PROJECT NUMBER **HEARING DATE**
R2014-01586 TBD

Tentative Tract Map No. 072939
Oak Tree Permit No. 201400027
Environmental Assessment No. 201400125

SUBDIVISION COMMITTEE REPORT

TRACT NO. 072939-New (updated 07-24-14).

TENTATIVE TRACT MAP

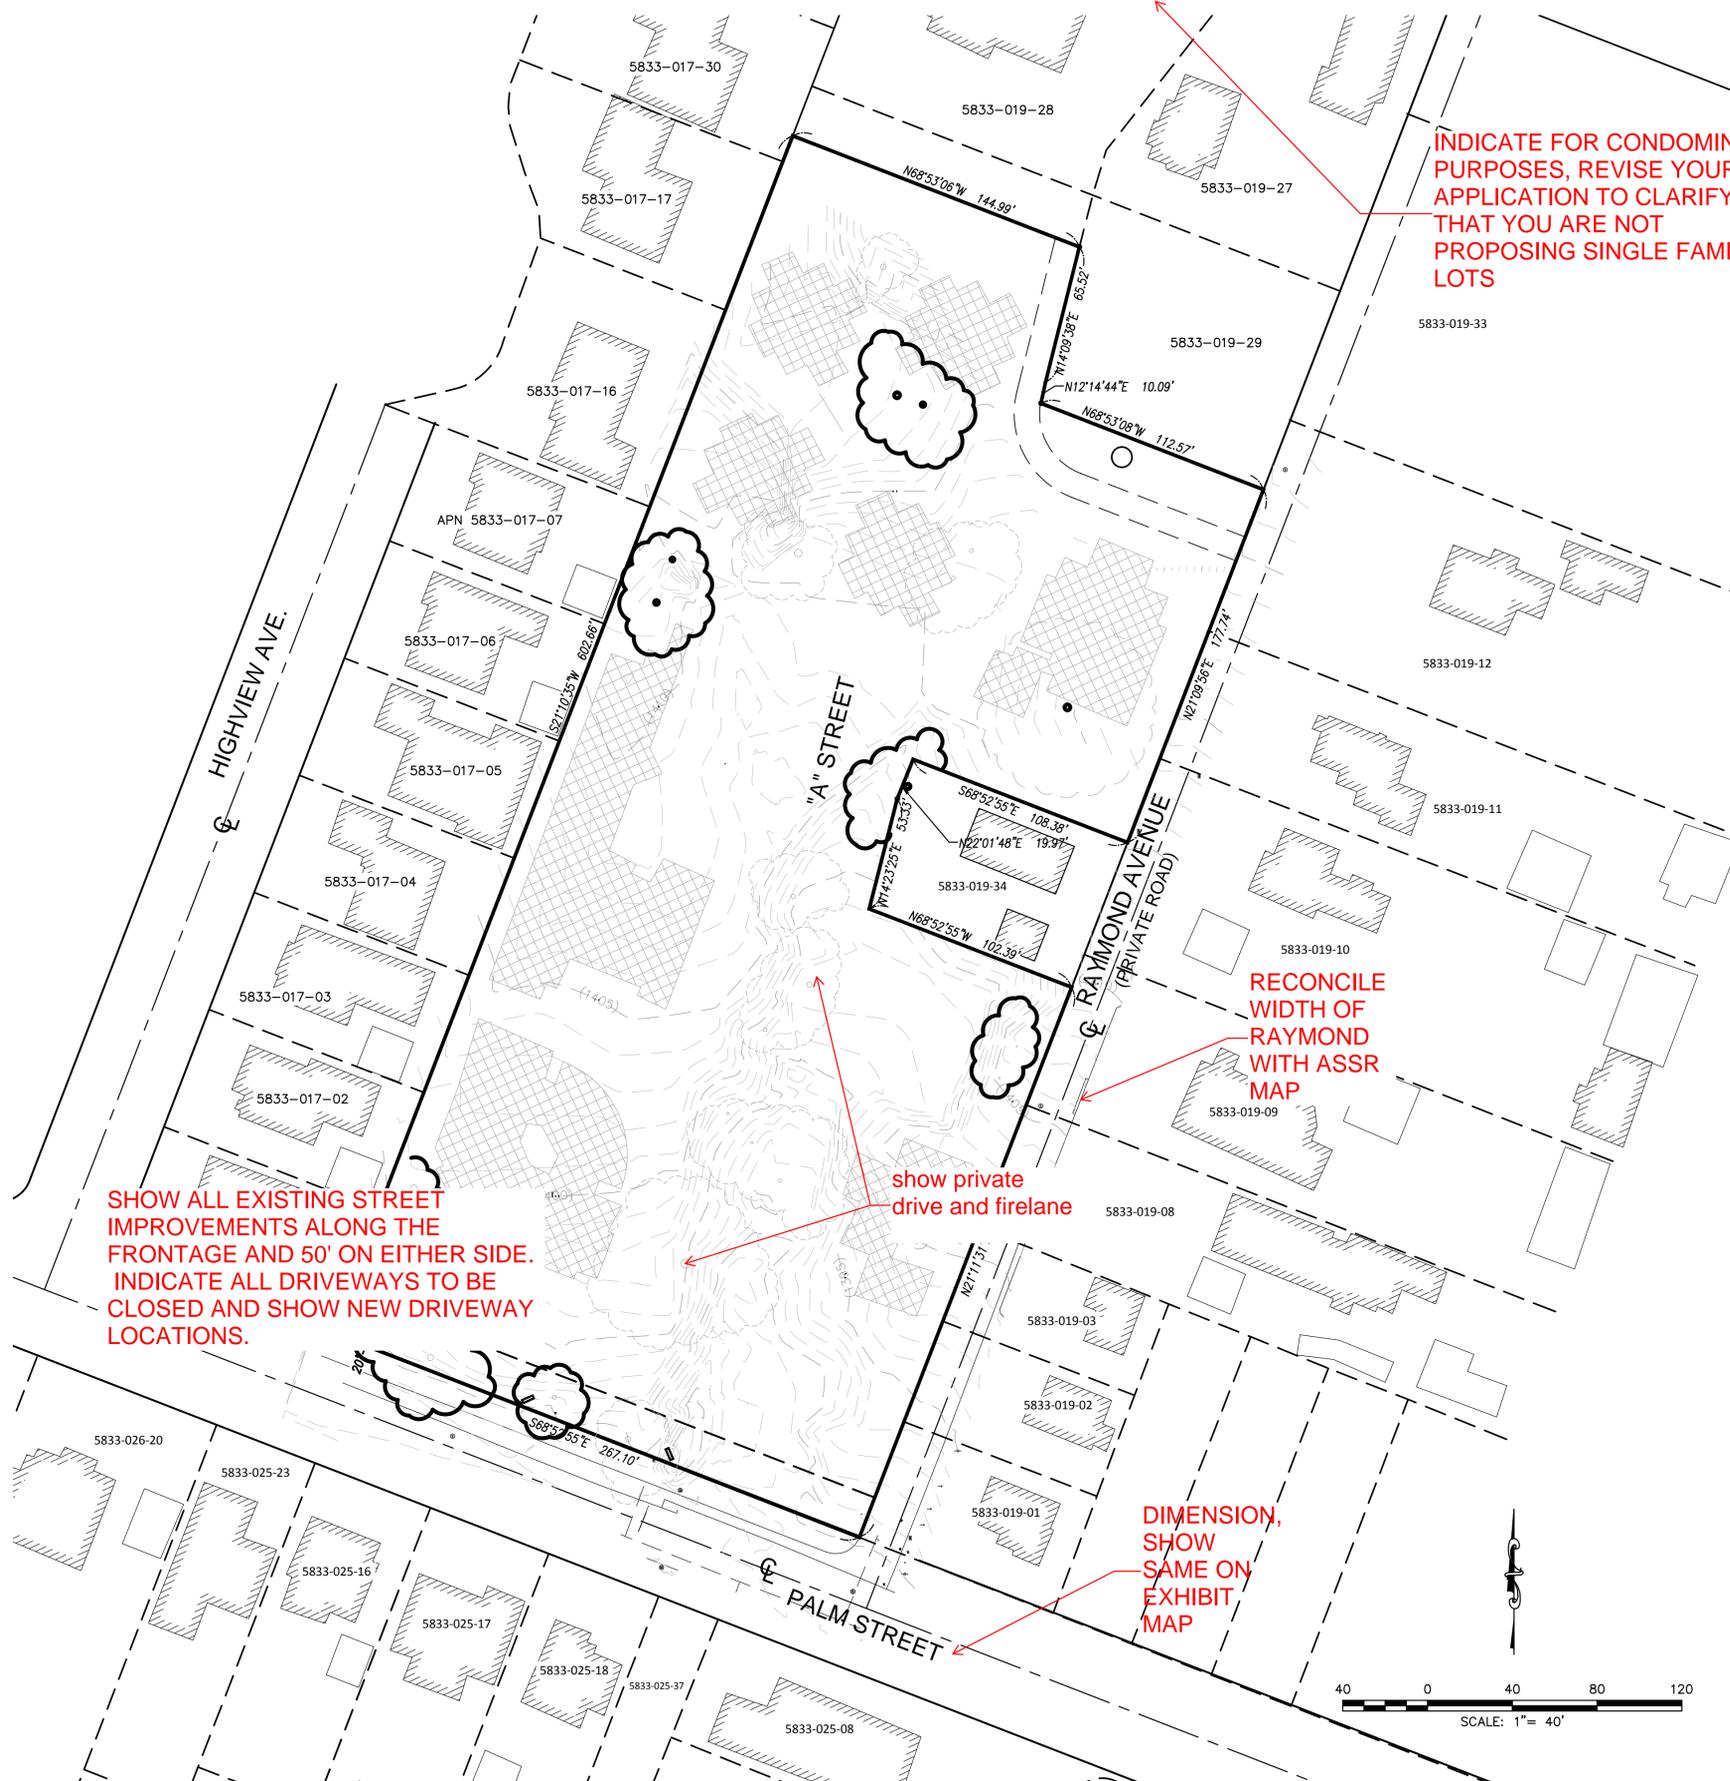
SHOW ALL EXISTING STREET IMPROVEMENTS ALONG THE FRONTAGE AND 50' ON EITHER SIDE. INDICATE ALL DRIVEWAYS TO BE CLOSED AND SHOW NEW DRIVEWAY LOCATIONS.

show private drive and firelane

RECONCILE WIDTH OF RAYMOND WITH ASSR MAP

DIMENSION, SHOW SAME ON EXHIBIT MAP

INDICATE FOR CONDOMINIUM PURPOSES, REVISE YOUR APPLICATION TO CLARIFY THAT YOU ARE NOT PROPOSING SINGLE FAMILY LOTS

ADD NUMBER

LABEL AS EXHIBIT MAP

TENTATIVE TRACT MAP

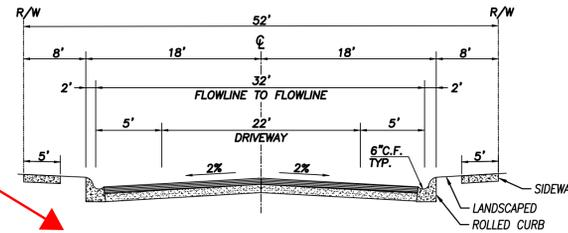
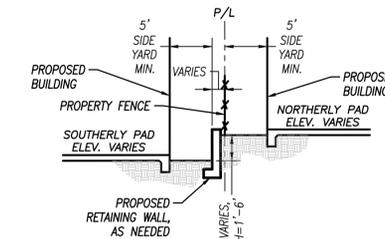
REMOVE THE OFFER OF DEDICATION (TYP.)

LABEL AS PVT DRIVE AND FIRELANE, SHOW SAME ON TENTATIVE MAP

cannot encroach into local depression of CB
